10/710,253

Rolf Hohmann

Office Action Summary

DETAILED ACTION

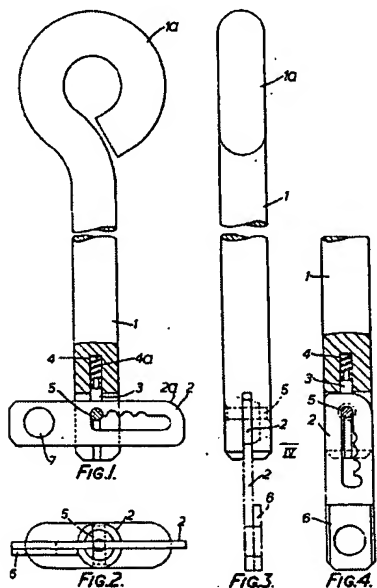
4. Claims 1-212,13 are rejected under 35 U.S.C. 102(b) as being anticipated by GB 1011329 to Cooke.

Cooke teaches an integrated pin and clip comprising a shaft member (1) and a locking member (2) at a first end of said shaft, movable between a first position coaxial to the shaft (Fig 3 and 4) and a second position generally perpendicular to said shaft (Fig 1 and 2), and retention means that secures the locking member in the first or second position (page 1 col 2 line 84 - page 2 col 1 line 36; page 2 col 1 lines 54 - col 2 line 71.) "1A" is the angled portion at a second end of the shaft. The first position allows for insertion and

removal into a receiving hole; the second position would not allow for insertion and removal into/out of a receiving hole
